3x800MW – NTPP-TALABIRA

Change in Speciation Points based on TCM resolution

Change in specification (Section B of Tender Specification)

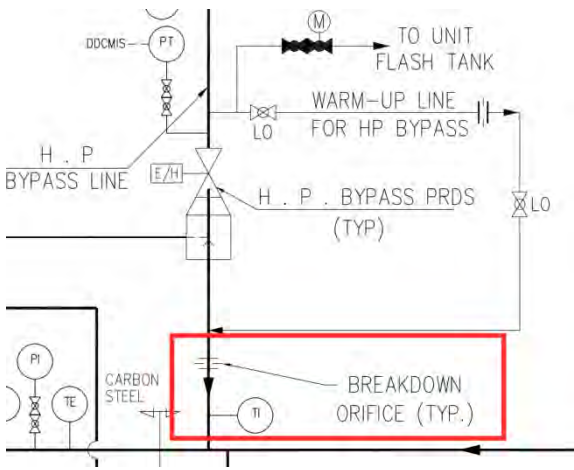
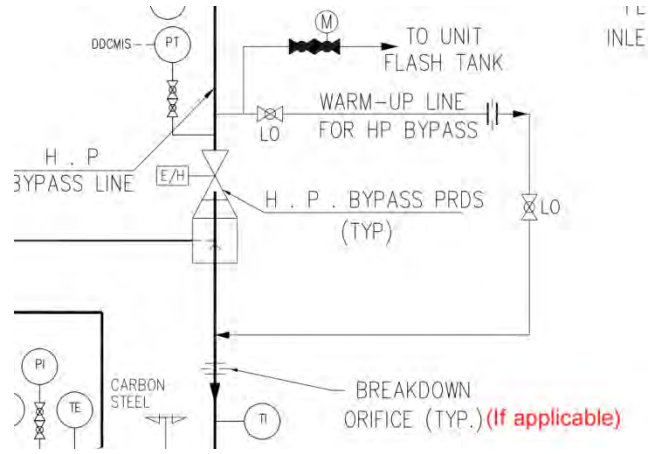
Sl. No.	TCM Reference	Tender Spec. Ref. (Vol / Sec/ Cl No.)	Description as in Specification	Description To be read as
56.	L&T / Annex-12 / S.No 735 & 738	VOLUME: II-IA /SECTION-I/ 4.02.01	<p>The required flow in this system shall be based on the requirement of each individual connected cooler in this system with respect to flow and terminal temperature rise as encountered during maximum possible thermal load conditions. Bidder shall list out the required flow and terminal temperature rise of each cooler and the number of individual equipment coolers (operating/standby) for each BTG unit compressed air system for main plant and DG set in his Bid proposal. The total required flow and heat load shall be computed by the Bidder by summing up the requirement of flow and heat load respectively for each of the operating individual coolers of TG and Boiler Island , compressed air system for main plant ,compressed air system of ash handling plant, equipments of FGD system (with booster pump required if any) etc. and DG set for each 800 MW unit. A minimum of 10 percent margin shall be considered over and above the total heat load to compute the design heat load and design DMCW flow in the closed circuit for each 800 MW unit.</p> <p>In computing the design heat load and design DMCW flow in individual DMCW system, Bidder shall ensure that the average temperature rise of DMCW is limited to ACW temperature rise under all circumstances.</p>	<p>The total required flow in this system shall be based on the requirement of each individual connected cooler in this system under maximum possible thermal load conditions. Bidder shall list out the required flow and terminal temperature rise of each cooler and the number of individual equipment coolers (operating/standby) for each BTG unit, compressed air system for main plant and DG set in his Bid proposal. The total required heat load shall be computed by the Bidder by summing up the requirement of heat load for each of the operating individual coolers of TG and Boiler Island, compressed air system for main plant, compressed air system of ash handling plant, equipments of FGD system (with booster pump required if any) etc. and DG set for each 800 MW unit. A minimum of 5 percent margin shall be considered over and above the total heat load and total flow to compute the design heat load and design DMCW flow respectively in the closed circuit for each 800 MW unit.</p>

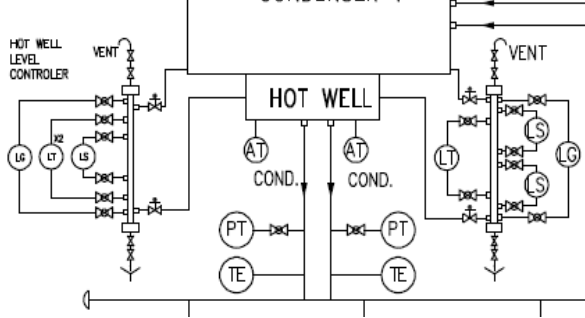
58.	L&T / Annex-12 / S.No 738	VOLUME: II IA /SECTION-V/ 4.04.00 b)	<p>a) Heat Load</p> <p>The required heat load shall be computed by obtaining the summation of the maximum permissible heat loads encountered in the respective operating coolers of Boiler and Turbine islands for each 800 MW unit, and BOP equipment which shall be cooled by DMCW system. A minimum of 10 percent margin over and above the total required heat load as obtained above shall be taken into account by the Bidder to work out the design heat load rejected by DMCW system for each 800 MW unit, BOP equipment and to be picked up by ACW system for the same.</p> <p>b) Flow</p> <p>Design DMCW flow rate shall be computed by obtaining the summation of the required flow rates to each individual operating coolers cooled by DMCW system under maximum permissible thermal load conditions for each 800 MW unit. The design DMCW flow rate shall be equally shared by the operating plate heat exchangers.</p> <p>The design flow rate in the clarified water (ACW) side of</p>	<p>a) Heat Load</p> <p>The design heat load rejected by DMCW system for each 800 MW unit and common system / equipment and to be picked up by ACW system shall be computed as per Clause 4.02.01, Section I, Vol II-IA.</p> <p>b) Flow</p> <p>Design DMCW flow rate for PHE design shall be computed as per Clause 4.02.01, Section I, Vol II-IA. The design DMCW flow rate shall be equally shared by the operating plate heat exchangers.</p> <p>The design flow rate in the clarified water (ACW) side of the operating plate heat exchangers for each unit shall be equal to the total required ACW flow rate in all the operating Plate type Heat Exchanger (PHE) plus ACW flow for common station Auxiliaries under design heat load. The design ACW flow rate shall be equally shared by the</p>

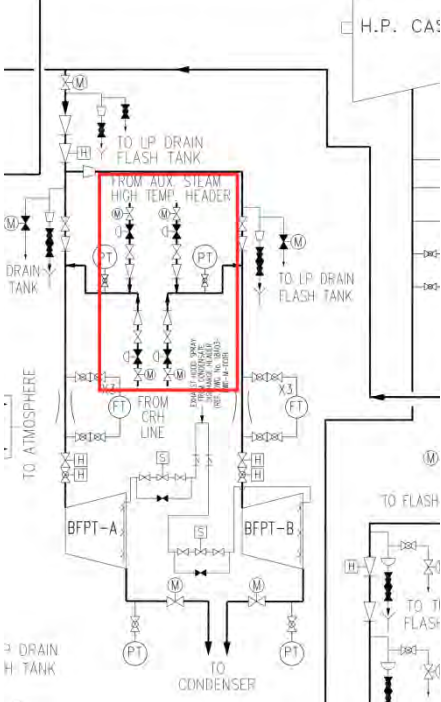
62.	L&T / Annex-5 / S.No 306	18A03-DWG-M-001D Flow diagram for extraction steam system and heater drain & vents system	NRVs in the Extraction line to BFPT from IP Turbine.	The ordinary NRV in the common extraction line to BFPTs A & B between the motorized isolation valve and the QCNRV at Grid C6 of the Tender drawing is deleted.

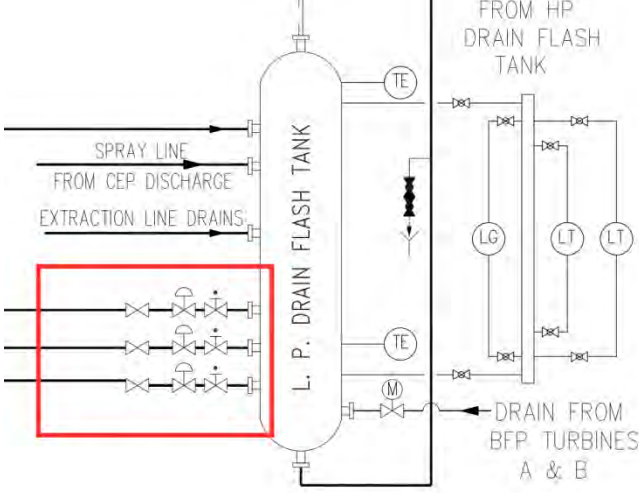
Sl. No.	TCM Reference	Tender Spec. Ref. (Vol / Sec/ CI No.)	Description as in Specification	Description To be read as
63.	L&T / Annex-5 / S.No 308	18A03-DWG-M-001D Flow diagram for extraction steam system and heater drain & vents system	Control Valve in steam supply line to BFPT from auxiliary steam header and CRH line :	Following new note added in the Tender P&ID: 13. Alternatively, common control valve for steam supply line to each BFPT from auxiliary steam header and CRH line as per Bidder's standard practice shall also be acceptable.

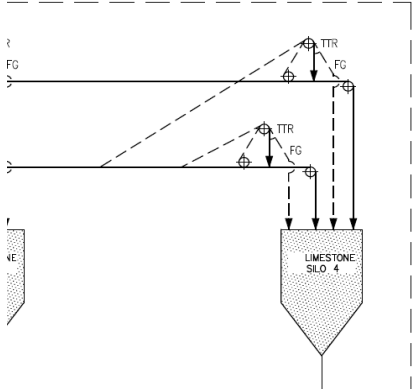
6.	Annexure I2.1 , Sl. No.537	Vol-II.H3 Sec-I 5.08.3.r Pg no: 21 of 48	Each mist eliminator face shall be automatically washed for a duration of at least one minute every hour. However, only one mist eliminator face of a given mist eliminator shall be washed at a time; the back side (top) of the first	"Each mist eliminator face shall be automatically washed for a duration of at least one minute every hour. However, only one mist eliminator face of a given mist eliminator shall be washed at a time; the back side (top) of the first mist eliminator and the

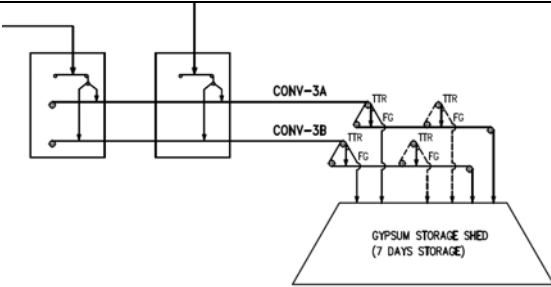
9.	Annexure I2.1 , Sl. No.543	Vol-II.H3 Sec-I 5.19.4 Pg no: 29 of 48	Computational Fluid Dynamics (CFD) Modelling	"The Bidder shall perform model study (CFD modelling of complete system to achieve an optimum size and layout of the ducting and absorber internals considering uniform distribution of gas, appropriate velocity distribution, minimum pressure
